SITE PLAN APPLICATIONDate 2-22-88NAME OF PROPOSED DEVELOPMENT Buffalo Creek Shopping Village No 2NAME OF PROPERTY OWNER/DEVELOPER Buffalo Creek Development CorpADDRESS Box 369, Rockwall, TX PHONE 771-5238NAME OF LAND PLANNER/ENGINEER Chuck Hodges, Harold EvansADDRESS Bridge Rd, Rockwall TX PHONE 771-0044TOTAL ACREAGE 2 acres CURRENT ZONING P.D.NUMBER OF LOTS/UNITS 1SIGNED [Signature]

Case No. 88-13 CUP

RETAIL NURSERY SITE PLAN

Notes on Whittle Garden Center

LEFT ELEVATION

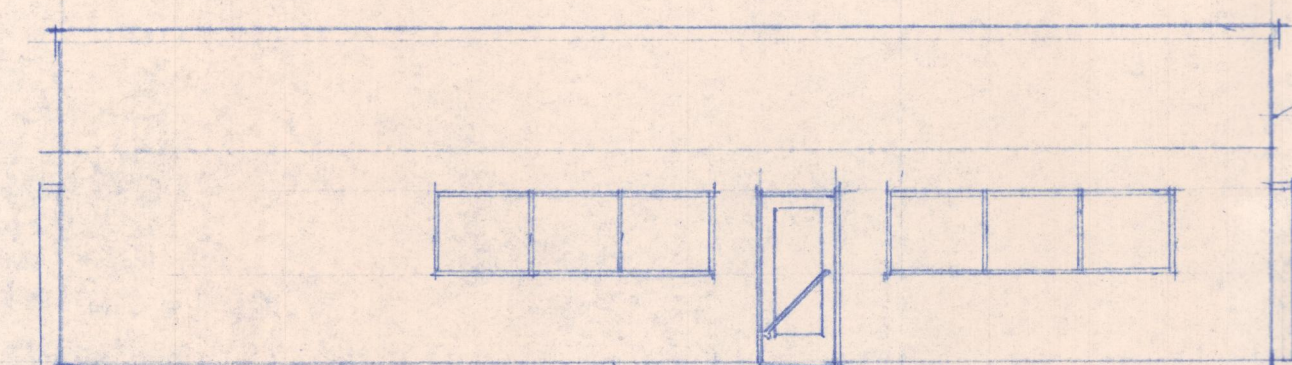
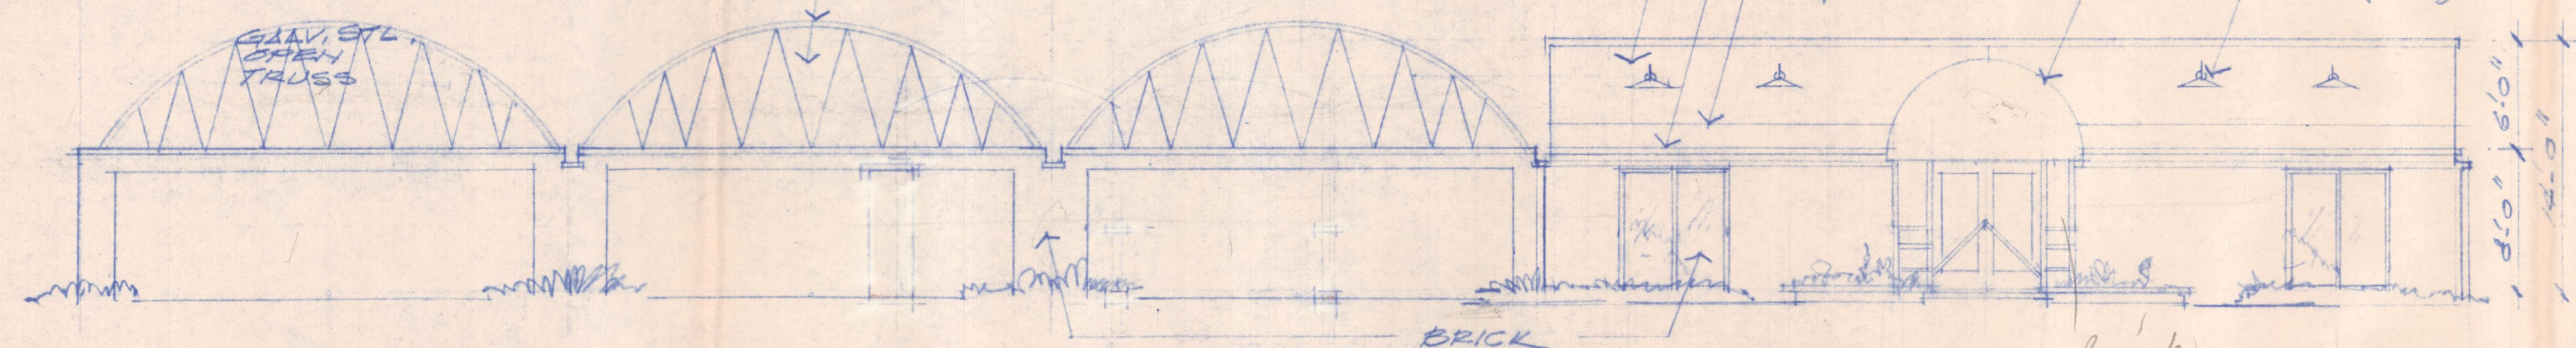
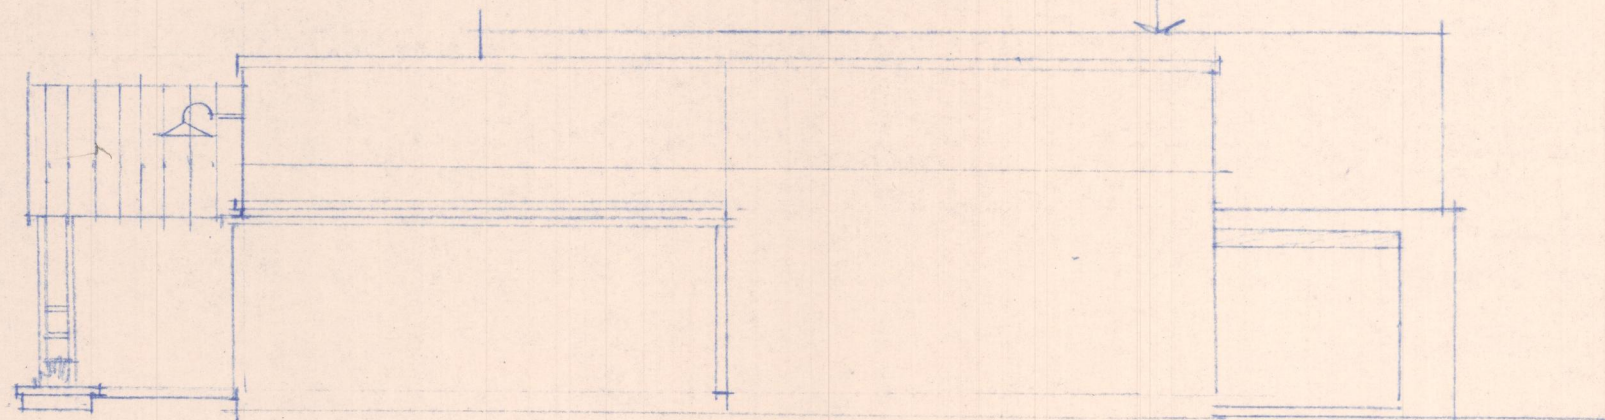
2. That the front and sides be all brick.
3. That the fence be a 6 ft. concrete flat formed wall with a brick cap and 2 foot brick pilasters every 30 feet from face of building to rear property line.

4. That the entrance not exceed 30 feet in width.
5. That the sales area/office have a hip or gable roof with minimum 6/12 pitch or a mansard roof a minimum of 8 ft. from the plate line; constructed of tile or metal standing seam.

17. Where is brick and where is
cult wall
